Red Chris Mine Site

Review of Tailings Impoundment Design

Red Chris Mine Site
Review of Tailings Impoundment Design

Figure 5.1 Final Design Section for North Starter Dam

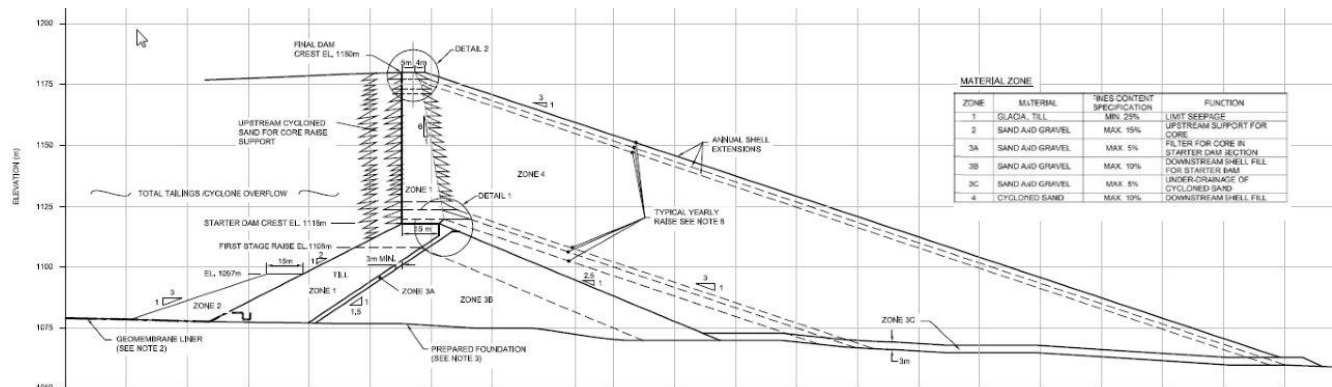
The basic tailings dam design, as shown in section on Figure 5.1 is to raise the north and south dams using centerline construction above the starter dam. What follows is a description of our understanding of the design and operation of the North Dam. The South Dam is a similar design, except that there is presently no plan to include a core in this dam.

The design and construction of the starter dam is described in Section 3 so we will start with a review of the design of the tailings dam above that. The North Dam will be constructed with the tailings themselves. The rougher tailings will be stripped of pyrite and cycloned to produce a coarser non-acid generating angular sand. This cyclone underflow sand will then be used to construct sand cells first on the downstream toe of the starter dam, then to raise the dam using cell construction on the downstream side and spigotting on the upstream side of the crest. Cleaner tailings will be discharged directly into the pond. The dam will eventually be about 100 m high.

A compacted glacial till core will be raised with the dam to reduce seepage in the downstream cell constructed zone. Except for a drain on the foundation from the downstream toe of the starter dam to the downstream toe of the hydraulic fill section, no other drains/filters are planned for the downstream hydraulic fill section. As described in Section 3, the blanket foundation drain downstream of the North Starter Dam is an important element that still requires detailed design.

Figure 5.2 Tailings Deposition from Muck 3D at El. 1120 m

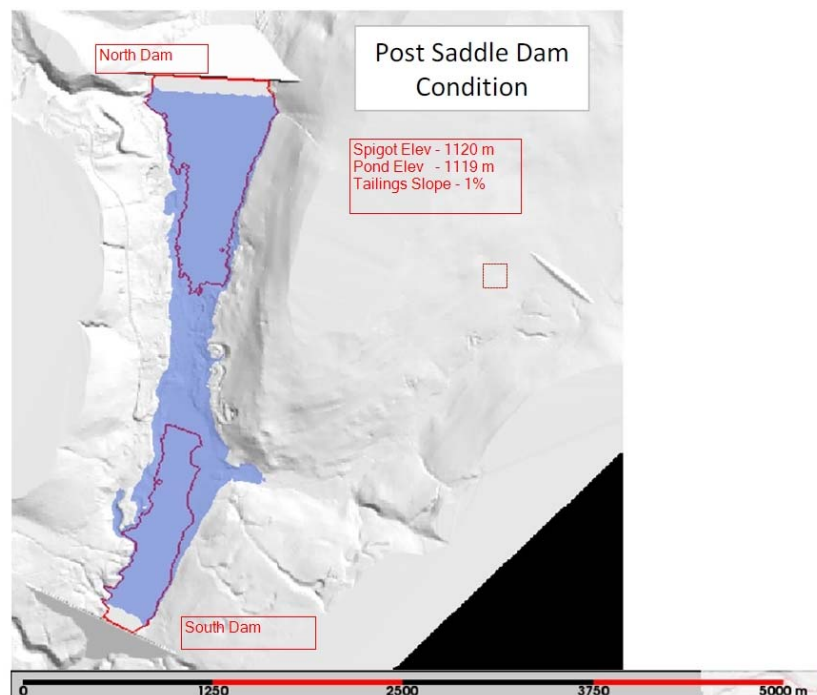
The illustration below (Figure 5.2) shows the extent of the water pond and the red tailings outline at 1120 m. This is for a tailings slope overall of 1%, a beach width of 100 m and no PAG tailings deposition. If the tailings slope were flatter then the unlined water pond outline will be less. The steeper the subaqueous tailings slope the greater the free water pond size (without tailings liner). This simple illustration demonstrates that seepage loss estimates are dependent on the deposition plan.

A large area upstream of the NSD has been opened up for borrow of dam materials. These areas should be mapped and correlated with the existing geologic model. In addition, the surface should be scoured for open work gravels where tailings could be lost to the pervious foundation soils. This surficial geological mapping exercise should be used by the designers to confirm that the tailings will not pipe into the pervious foundation soils. The water balance and seepage models need to be continually updated to confirm the integrity of the tailings liner.
